# Bezares USA Technical Bulletin

**Endurant transmissions may inconsistently receive PTO feedback signals. Changing the PTO confirmation (Ball Switch and Harness) may improve communication to the Eaton Endurant and PACCAR Transmissions.**

**4100/4110 MECHANICAL BALL SWITCH CONVERSION KIT**

KIT #s **PT90100899-13** (1&3) assembly or **PT90100899-24** (2&4) assembly

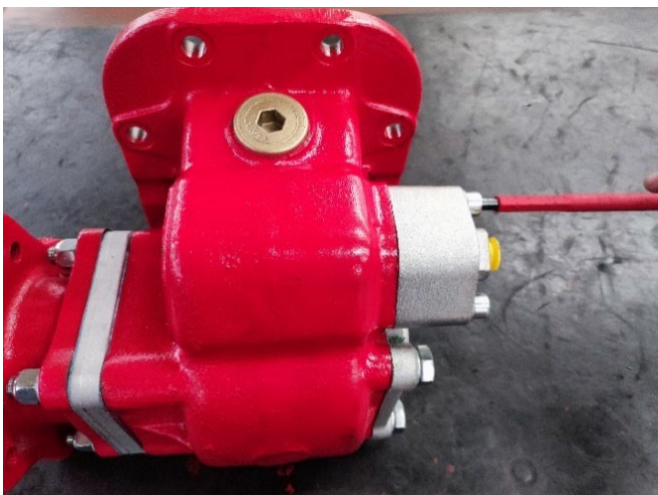
1. Clean any debris from switch carrier cover.  
Remove the cover and save the screws.

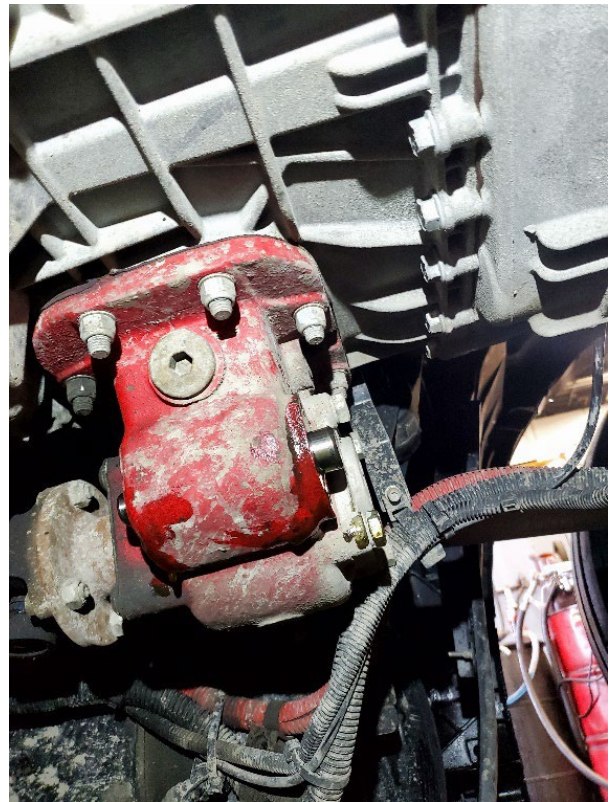
2. Remove the screws from the old switch carrier.

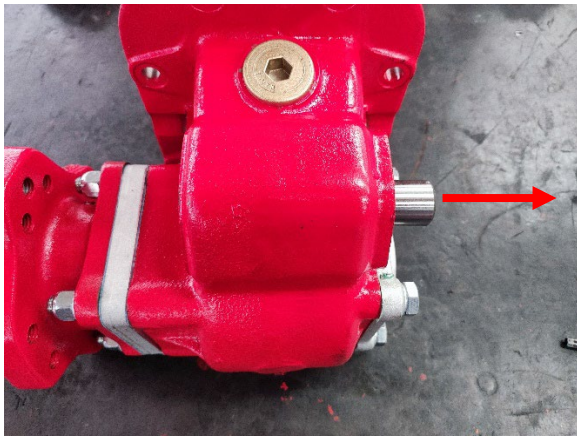
3. Remove the screws from the piston carrier cover.  
Make sure the piston carrier is clean.

Remove the cover, save it and the screws.

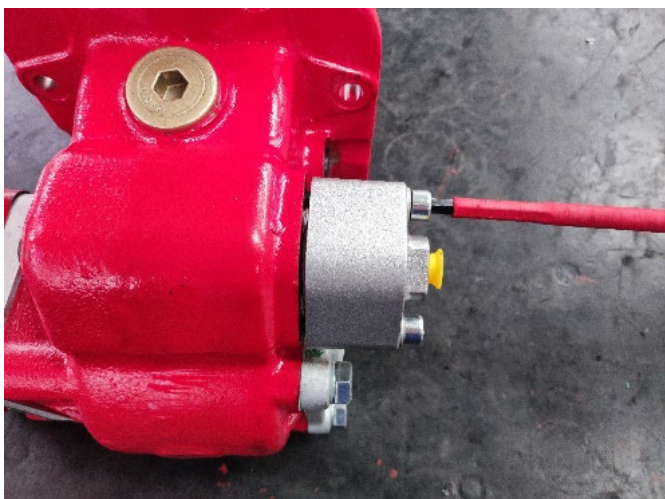
6. Push in piston. Release and it should spring back.

**Warning!**

If piston does not spring back, then PTO will have to be removed for inspection. If it is found that internal shifter components have become dislodged, the unit will need to be returned to authorized Bezares distributor for rebuild.

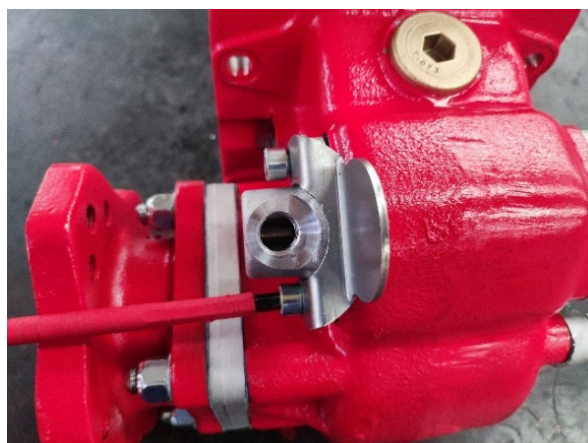
7. Install new O-Ring. Apply Loctite 270 to screws for piston carrier. Torque to 16-22 lb.-ft.

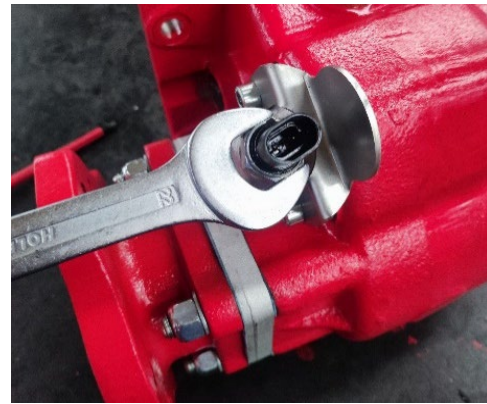
10. Apply Loctite 270 to the screws for the switch carrier cover, then install protection plate. Torque to 16-22 lb. ft.
